Subject: AP1000 Response to Request for Additional Information (SRP 6)

Response to Request for Additional Information on SRP Section 6

RAI Response Number: RAI SRP6.2.2-CIB1-28: Concrete as Debris
Revision: 0

Figure 1 Target Pressure Distributions from NUREG/CR-2913

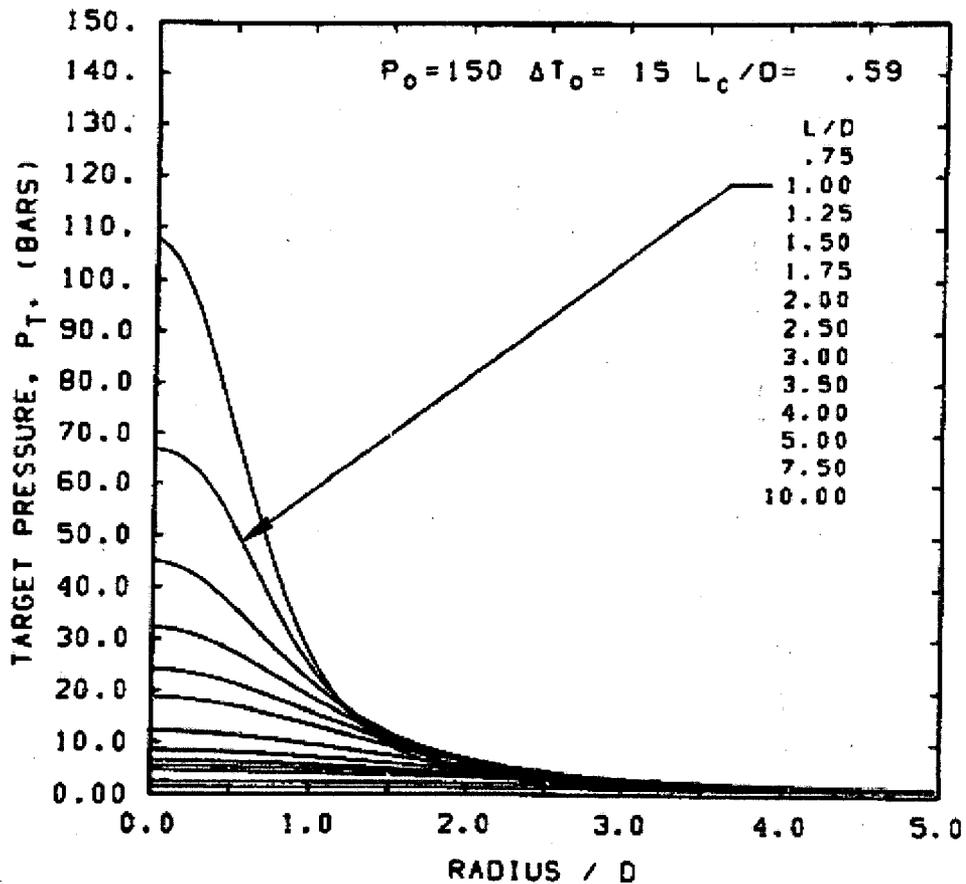
Please clarify how you include the effects of concrete as a debris source term for small-break and large-break loss-of-coolant accidents. In your response, please address the following:

- a) Identify the locations of the concrete that is considered a potential source of particulate, coatings, or chemical debris.
- b) How is the concrete treated as a source term for coatings debris (inside and outside the ZOI)?
- c) How is the concrete treated as a source term for latent particulate?
- d) How is the concrete treated as a source term for LOCA-generated particulate?
- e) What locations were considered when calculating the amount of chemicals dissolved from concrete?

For flow from a pipe break due to a postulated LOCA, the escaping fluid begins to flash at the break location. The flashing begins at the outer surface of the jet and continues inward of the jet until the core of the jet is reached. Characterizing the jet flow as a function of the distance, L , and the pipe break diameter (D), LOCA jets have been evaluated to be fully expanded with an associated major decrease in pressure within $4 L/D$. The rapid depressurization associated with LOCA jets has been studied experimentally in tests such as the Marviken test program (Reference 1) and analytically in work such as that presented in NUREG/CR-2913 (Reference 2). How quickly the subcooled jet depressurizes is demonstrated in Figure 1, below. Figure 1 was presented in Reference 1 as Figure 2.8. For a jet with a fluid source at 150 bar (2180 psi) and a subcooling of 15°C (103°F), at and $L/D = 4$, the calculated stagnation pressure is reduced to approximately 6 bar (87 psi).
